**SEWPCC Upgrading/Expansion  
Conceptual Design Report**

**SECTION 21 - Building Envelope and Structural Assessment**

**PARTIAL PLAN**  
1 -  
1:100

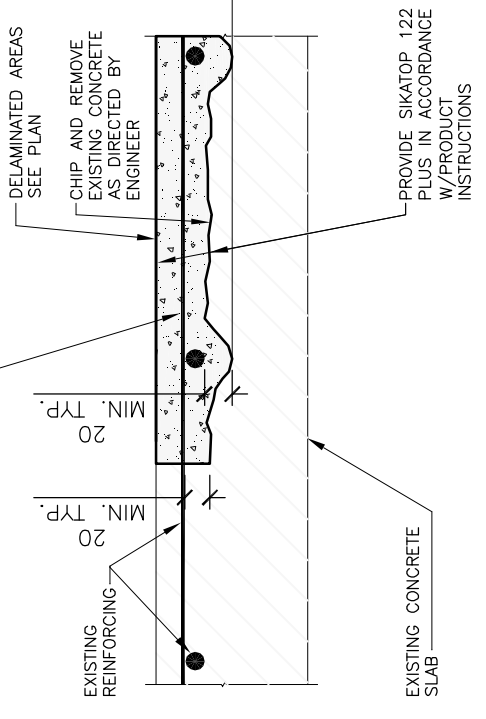
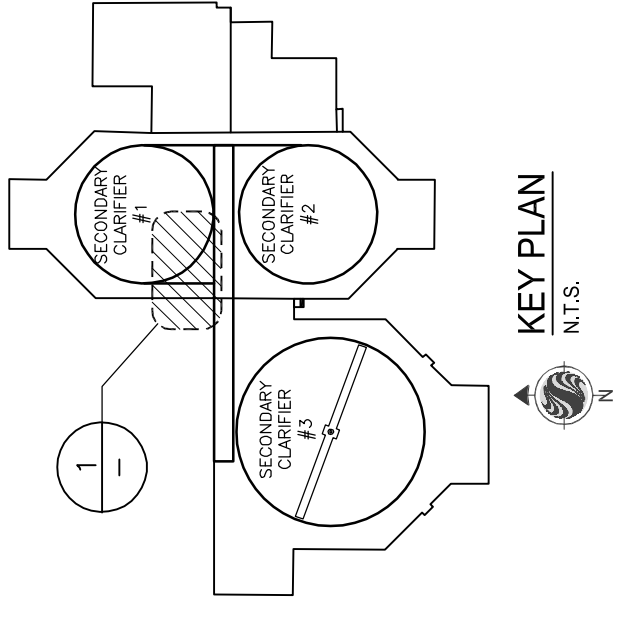
**Comment:** Concrete has delaminated in the location noted. Delamination is likely due to insufficient concrete cover of the reinforcing steel. Moisture is allowed to reach the reinforcing steel surface causing it to rust and expand. The thin concrete cover does not have the strength to resist the expansive forces, resulting in concrete delamination. Loose and delaminated concrete in the area noted should be removed and repaired. Exposed reinforcing steel should be examined to confirm that rust is limited to the surface only. Reinforcing steel surfaces should be cleaned prior to replacing delaminated concrete. Subsequent investigation of the concrete at the other apron areas suggest that the delamination is limited to the area noted in the report. The aprons were checked for delamination by hammer “sounding”. See Figure 21.1.

**Action:** Remove loose and delaminated concrete, examine reinforcing steel, and repair concrete surfaces.
